**Subject: Comments on Draft EIR for Rancho Canada Village Specific Plan**

## Executive summary

Figure 2-7  
Preliminary Grading and Drainage Plan  
Vesting Tentative Map

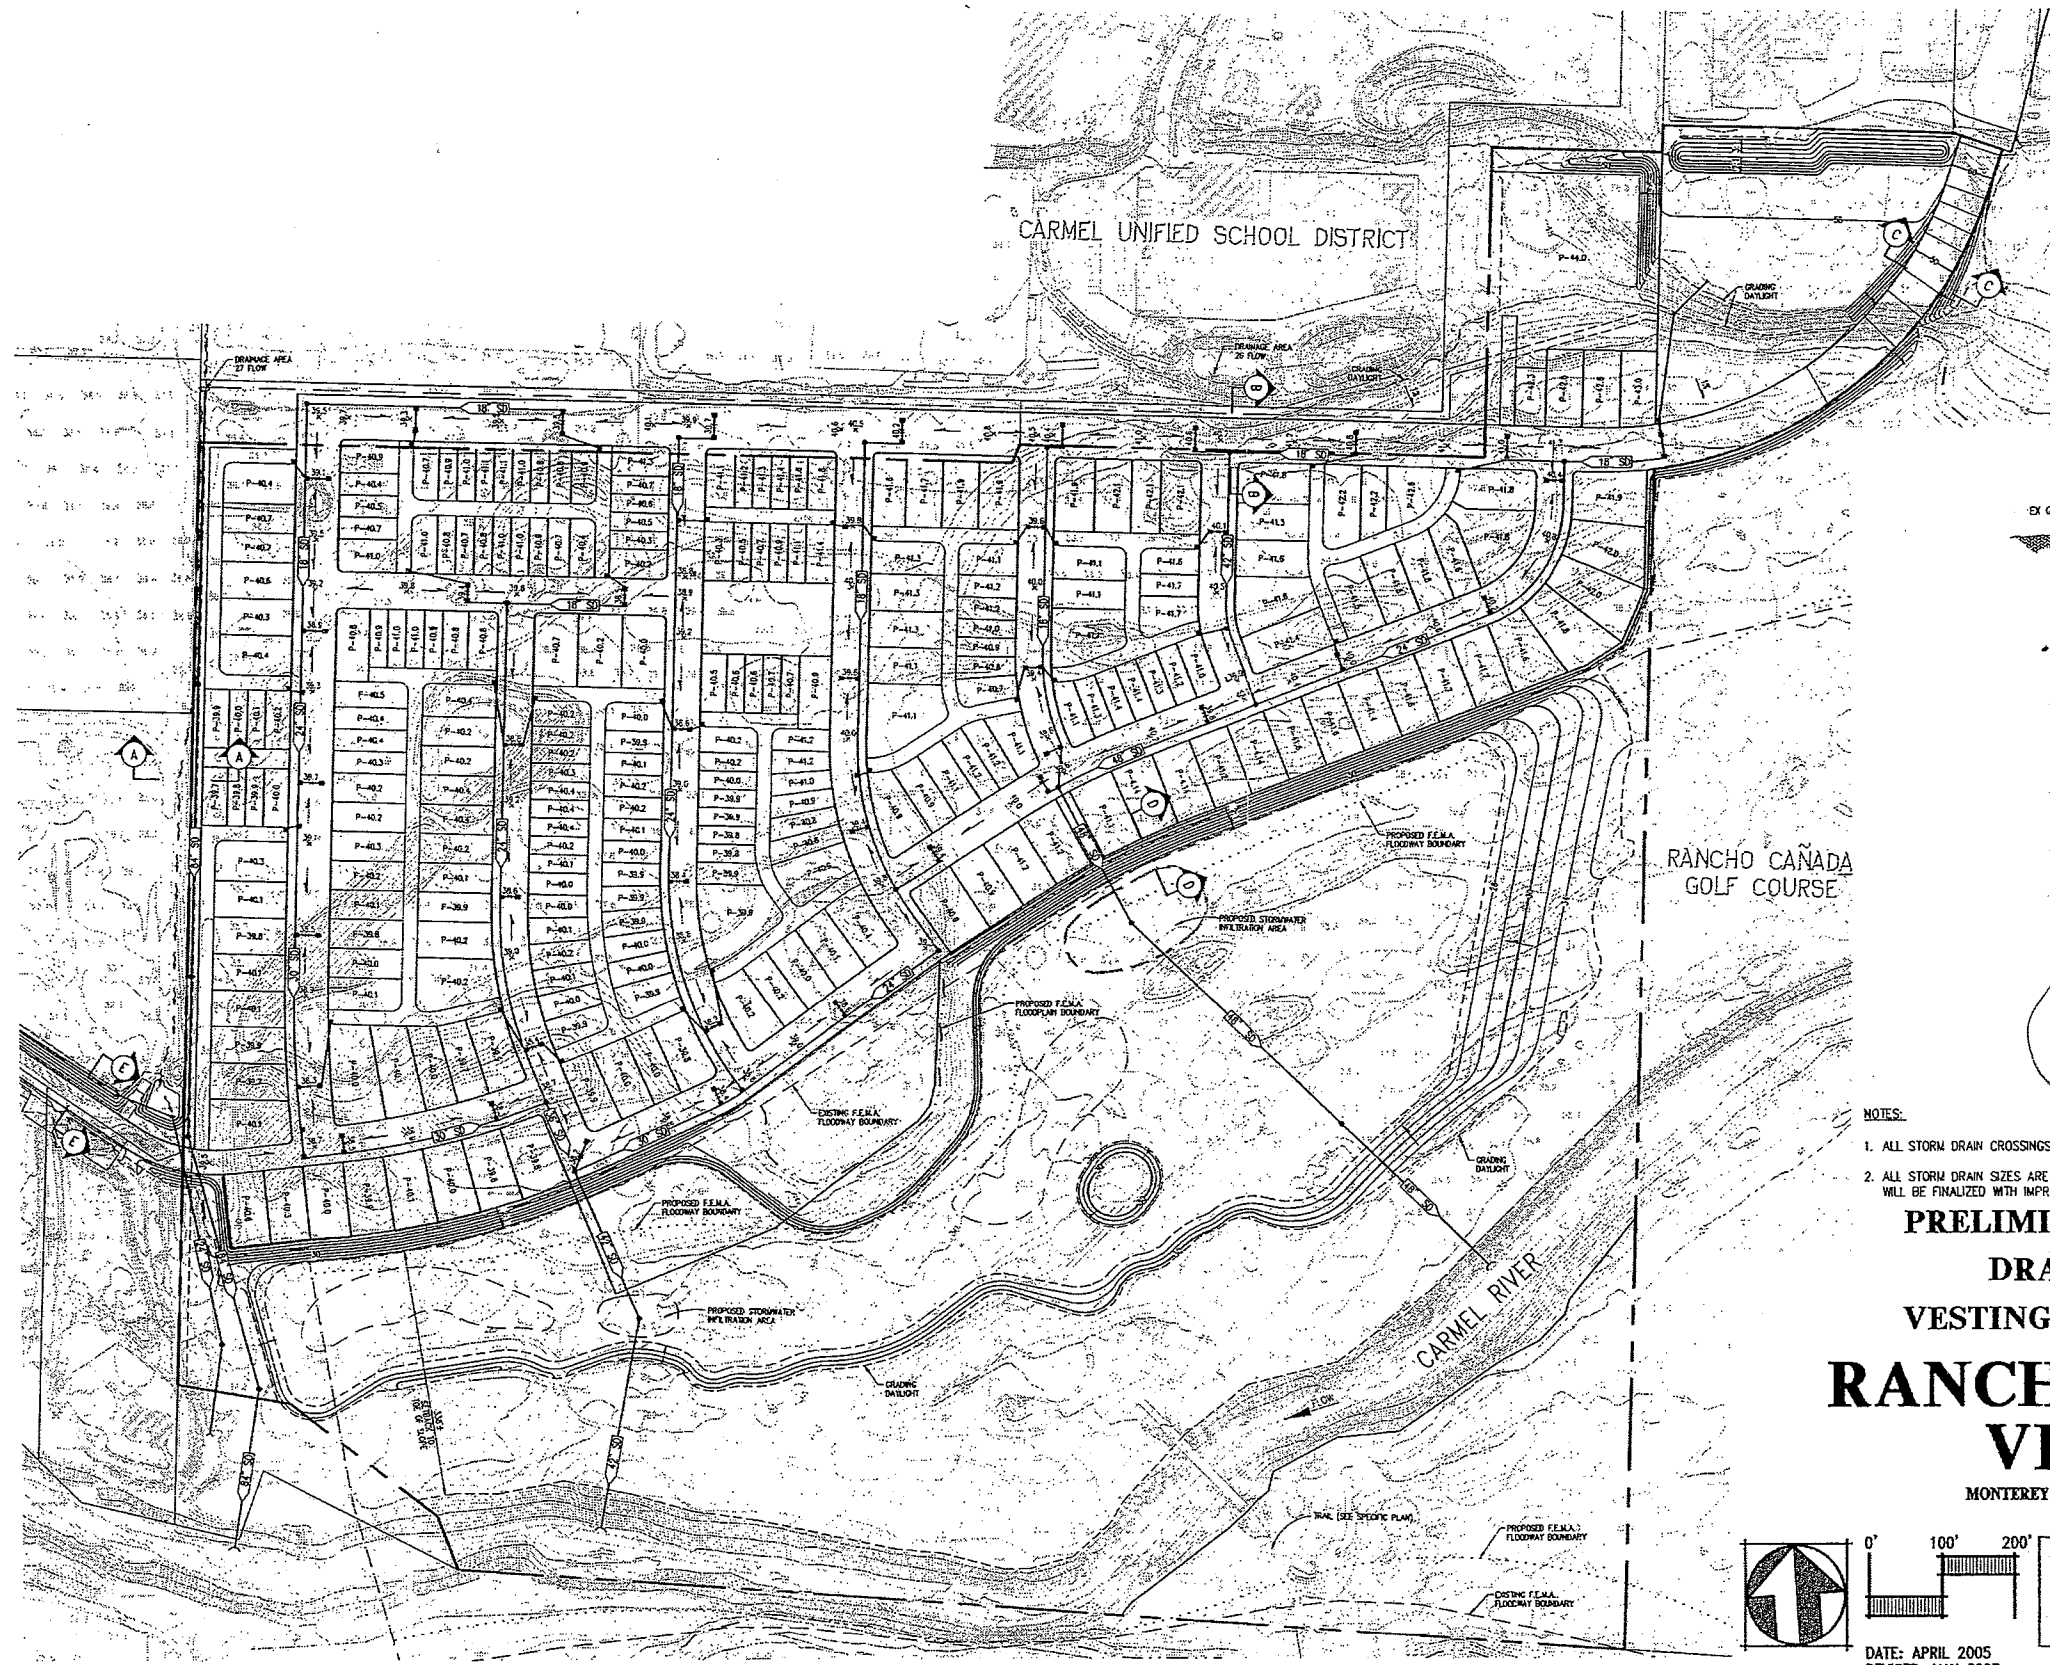
18. Figure 2-7. Please explain in detail how the large drainage pipe on the west end of the project will collect storm waters from the middle school from the Dow and Clark properties. If this drain has a flap gate, please explain what happens to storm water run off from this project when the flap gate closes

41. Figure 2-7, Preliminary Grading and Drainage Plan, Section D-D states "proposed Rio Road elevation 39.5 feet per CSA50 flood control final report. (DEIR 9) Please explain what report. Please explain in detail why no modeling has been done to reflect what happens when there is a high river/high tide/ and heavy local rainfall situation.
